TECHNICAL NOTE: LANDSCAPE & VISUAL RESPONSE

Lagan Homes

West of Ratby

- 1.1 This Technical Note has been prepared by FPCR Environment Design Ltd, on behalf of Lagan Homes.
- 1.2 The Note is in relation to the outline planning application submitted by Lagan Homes (Planning application ref. 24/00914/OUT).
- 1.3 FPCR prepared a Landscape & Visual Appraisal (LVA), (September 2024), to accompany the application.
- 1.4 The LVA was prepared based upon GLVIA3¹.
- 1.5 The purpose of the LVA is to review landscape character and visual amenity, and to assess the resulting landscape and visual effects of the Proposed Development (i.e., that is presented by this Outline Planning Application) on the receiving landscape receptors and visual receptors.
- 1.6 This Technical Note provides a response to The Landscape Partnership's (TLP's) review of the LVA. The review was undertaken for Hinckley & Bosworth Borough Council. (H&BBC)²

(Extract 1. Footpath S2 identified in 'yellow', with the site indicatively marked in 'red')

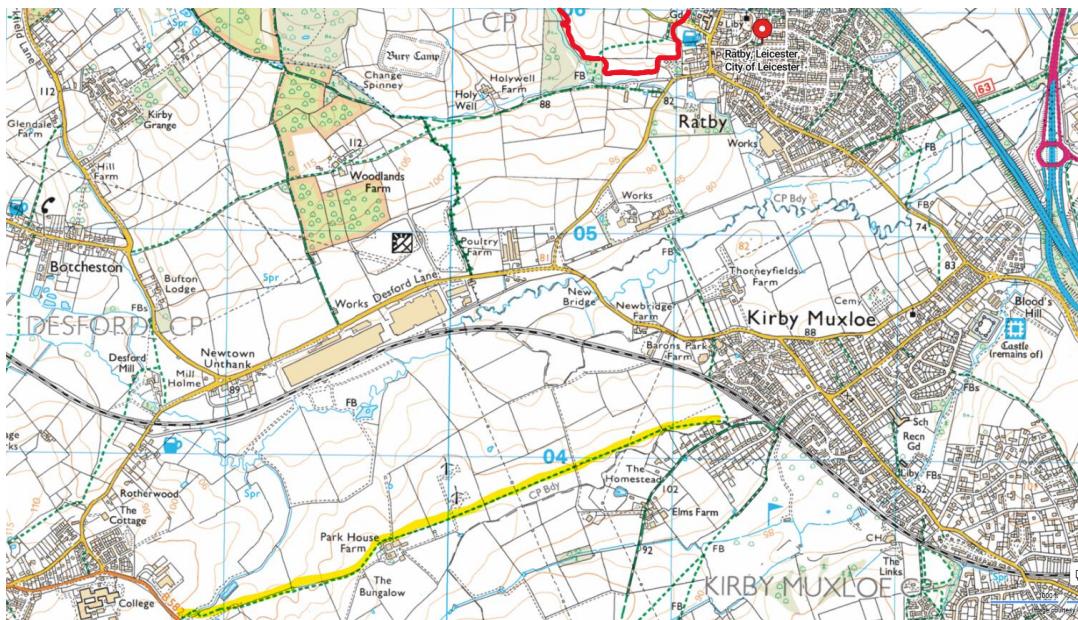
- ***Appraisal of views from the ridge of higher ground at Kirby Muxloe, particularly from Public Footpath S2 (E: 451128 N: 304162)***

3.8 To provide additional information to assist the decision making process, visual effects from Public Footpath S2 is explored below. This Public Footpath follows an elevated course between Kirby Muxloe and Desford, as shown below in **Extract 1**.

3.9 There are opportunities for extensive views northwards across the lower lying Rothley Brook valley towards Ratby. **Figure 1, Viewpoint 16** (included in this Technical Note), provides a representative view from the footpath. Receptors have views of agricultural fields, woodland, pylons, and built elements.

3.10 The northern and upper parts of the site (north of Burroughs Road) are visible, albeit distant (the footpath varies between 1.6km -3km from the site). There would be some partial views of the northern parts of the Proposed Development with the development being observed within the context of the built-up area of Ratby, which includes views of housing at Martinshaw Meadows and Stamford Street. New structural planting, alongside established woodland and overlapping hedgerows and tree cover within the intervening landscape, would filter views of the built form.

3.11 Given the receptors sensitivity (High) and judged magnitude of change (Low) - which takes into account the overall distance of the receptor from the proposed development; existing screening elements in the landscape such as landform and vegetation; and existing built elements in the view (ie Ratby), which development would be observed against - , effects are judged to be Minor Adverse on completion, reducing to Negligible Adverse in the longer term (year 15). This takes into account of the maturing nature of the GI framework, which would assist in assimilating the development into the landscape.

(Extract 2: Public Footpath 43 shown in 'yellow' with the site indicatively marked in red)

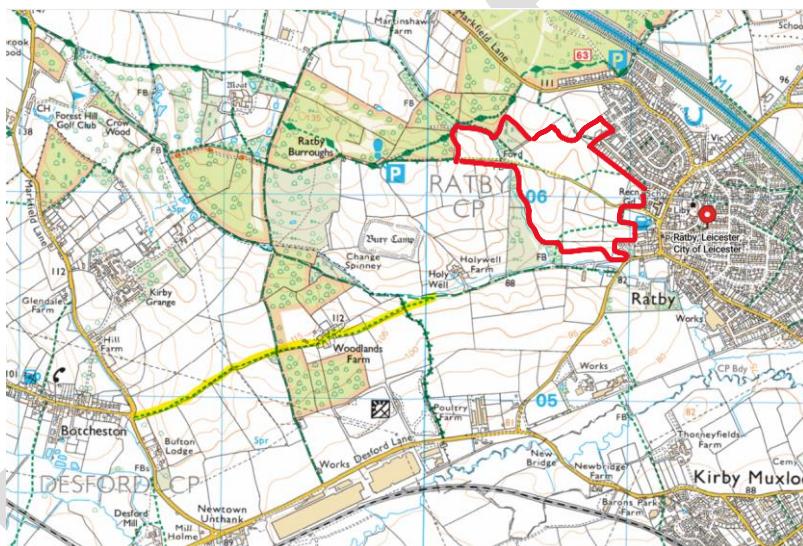
"The LVA includes a reasonable description and assessment of the likely visual effects. TLP would, however, note that visual effects would also be experienced from Public Footpath R43 (E: 449592 N: 305312) and Byway R56 (E: 449974 N: 305375) which are not covered within the appraisal" (para 5.3.11)

3.15 Footpath R43 lies to the west of the site and runs from Holywell Farm to Botcheston, via Woodlands Farm, as shown below in **Extract 2**.

3.16 The extent of visibility across the landscape from Footpath R43 varies on account of the screening effects of landform, hedgerows and woodland cover. Existing woodland that borders the western parts of the site at Wirlybones Wood and Pear Tree Wood, together with landform variations in the intervening landscape would prevent views of the proposed development, albeit there will be some partial views of the development from some occasional locations along the route, specifically near Woodlands Farm. **Figure 2, Viewpoint 17**, is taken from the field immediately east of the farm. The site is not easy to percept because of screening elements of landform and tree cover in the intervening landscape, but buildings at Martinshaw Meadows and Stamford Street are visible, which help to locate the site.

3.17 Given the receptors sensitivity (High) and magnitude of change (Low) - which takes into the limited opportunities for views of the Proposed Development as a result of distance and screening elements in the landscape, and the fact that the development would be seen against built features already apparent in the view with new housing seen against the backdrop of the existing built up area of Ratby, - effects are judged to be Minor Adverse on completion, reducing

to Minor Adverse-Negligible Adverse in the longer term (year 15). This takes into account the maturing nature of the green infrastructure framework, which includes structural woodland within the western part of the site, which would assist in assimilating the development into the landscape and filtering views of the built form.

(Extract 4: Ivanhoe Trail Route 63 shown in 'yellow' with the site marked indicatively in 'red')

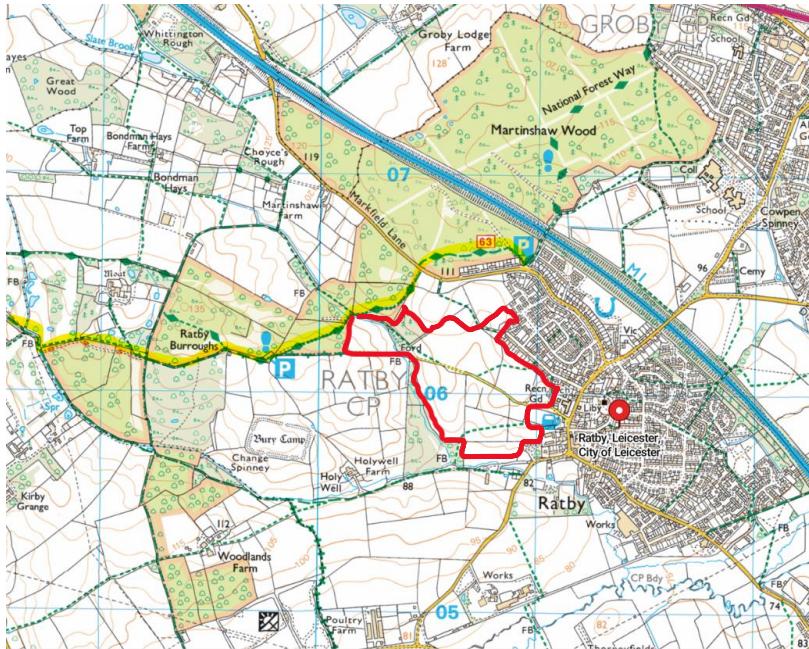
3.23 The TLP refers to "Views are also available from a section of the Ivanhoe Way (E: 449762 N: 306144)"

3.22 The Ivanhoe Way is a long-distance recreation route that lies beyond the study area. It is presumed that the reference by TLP is to the Ivanhoe Trail (Cycleway 63) which lies to the west and north of the site. To provide additional information, and to assist the decision making process, visual effects are summarised below for these receptors.

3.23 Within the Study Area the Ivanhoe runs from Ratby Burroughs, and follows part of Burroughs Road, near the Burroughs Wood Car Park, before heading northward into Pear Tree Wood and then continuing into Martinshaw Wood.

3.24 The majority of the route, within the Study Area runs through woodland such that visibility of the Proposed Development would be prevented. There would be some glimpsed views of the site's western most field which is proposed for green infrastructure uses. As the route approaches Martinshaw Wood views of the development would be prevented by intervening landform, green infrastructure uses and housing as part of the consented site off Markfield Road.

3.25 **Figure 4, Viewpoint 19** is taken from Burroughs Wood. There are views across to the east which includes views of housing at Martinshaw Meadows and Stamford Street. There would be some glimpsed views of the Proposed Development seen against the backdrop of the existing built edge of Ratby and it is considered that there would be no fundamental change to the viewing experience.

3.26 Given the receptors sensitivity (High) and magnitude of change (Negligible-Low), and the very limited opportunities for views of the development, effects are judged to be Minor Adverse-Negligible on completion and Negligible Adverse in the longer term (year 15).
